# UNITED STATES PATENT AND TRADEMARK OFFICE

APPLICATION NO.	FILING DATE	FIRST NAMED INVENTOR	ATTORNEY DOCKET NO.	CONFIRMATION NO.
10/550,635	09/22/2005	Gunter Barrenberg	BM-177PCT	1966
40570	7590	08/03/2010		
Lucas & Mercanti LLP 475 Park Avenue South New York, NY 10016			EXAMINER MERLINO, ALYSON MARIE	
			ART UNIT 3673	PAPER NUMBER
			MAIL DATE 08/03/2010	DELIVERY MODE PAPER

<b>Office Action Summary</b>	<b>Application No.</b> 10/550,635	<b>Applicant(s)</b> BARRENBURG ET AL.	
	<b>Examiner</b> ALYSON M. MERLINO	<b>Art Unit</b> 3673

## DETAILED ACTION

**FIG.8**

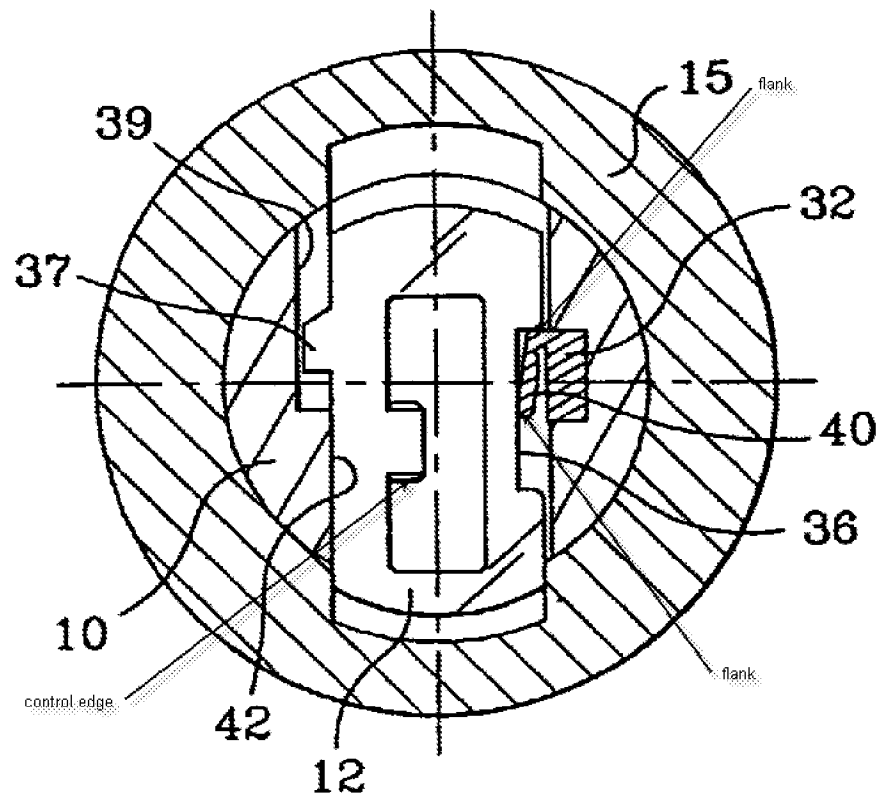
10. **In regards to claims 1-4**, Demouy discloses a lock cylinder (Figure 8) including a cylinder housing 15 and a cylinder core 10 rotatably supported in the housing (Figure 8), and a key 18 with a defined longitudinal profile being assigned to the core (Figure 9). Demouy further discloses a group of diametric shafts 14 arranged in a row in the axial direction of the cylinder core (Figure 1), which hold plate-shaped tumblers 12 that include longitudinal edges that are free to slide longitudinally along guide surfaces 42 (apparent from Figures 8 and 9) of the shafts. Demouy discloses that each tumbler has a control edge (see figure below) in correspondence with the longitudinal key (Figure 9), and each control edge being located at a defined height (apparent from profile of key, Figure 1). Demouy further discloses a radial opening 33 in the cylinder core for insertion of an insert 32, with an outer end (end near indicator of reference characters 32, Figure 8) of the insert never projects beyond an external contour of the cylinder core after insertion of the insert in the opening with the insert being fixed in position (apparent from Figures 8 and 9) in the opening, whereas an inner end (end opposite the outer end, closest to tumbler 12, Figure 8) always engages in a cutout 36 in the facing edge of the longitudinal plate edge of each of the tumblers (Figures 1, 7, and 8) during operation of the lock cylinder (apparent from Figure 9). Demouy also discloses that each of the tumblers are secured in the cylinder core (apparent from Figure 1), and that the insert consists of a non-displaceably positioned comb-shaped body (apparent from Figures 3 and 8) with teeth 40 extending from the comb-shaped body, with the tumblers

arranged in a common plane with the teeth (cross-sectional plane shown in Figure 8), with the teeth having inner ends that include a profile with at least one pair of oppositely-facing flanks (see figure below). Demouy discloses that the cutouts in the tumblers have at least one pair of opposing flanks 38 (Figure 7), and the flank pairs and the opposing flank pairs are arranged so that the control edges of at least two tumblers are at the same height (apparent from Figure 1). Demouy further discloses that in a rest position of each of the tumblers, only one of the flanks of a flank pair of the at least one pair of oppositely-facing flanks rests against one of the opposing flanks of the at least one pair of opposing flanks (apparent from Figure 8) and in an actuated position the other flank of the flank pair meets the other opposing flank (apparent that maximum displacement of tumbler 12 upward would have the bottom flank meet the other opposing flank, Figure 9). Demouy fails to disclose that the tumblers are spring-loaded, the at least one pair of opposing flanks of the tumblers are in different positions on each of the tumblers, and the teeth extend perpendicularly from the comb-shaped body. Cook teaches a lock cylinder (Figure 4) having tumblers 14 that are spring-loaded (Col. 22, lines 6-20), with each of the tumblers having a cutout (portion near reference character 14b, Figure 1), and that the cutouts of the tumblers have at least one pair of opposing flanks (portions engaging flanks of insert 16, Figure 4), which are in different positions on the tumblers (apparent from Figures 2 and 3). Cook further teaches a plurality of similar cylinder cores (Figures 4-6) can be used with a set of different combs (combs shown in Figures 5 and 7-13) that are provided with different profiles, with teeth 16a extending perpendicularly to comb-shaped body (apparent from Figures 2-6 and 8).

14. **In regards to claim 9**, Demouy discloses that the maximum point of the tooth profile (near upper flank, see figure above) is positioned in the cylinder core so that it “essentially” lies on a traverse plane (plane extending from side of core with insert towards side with reference character 37, Figure 8) of the cylinder core.
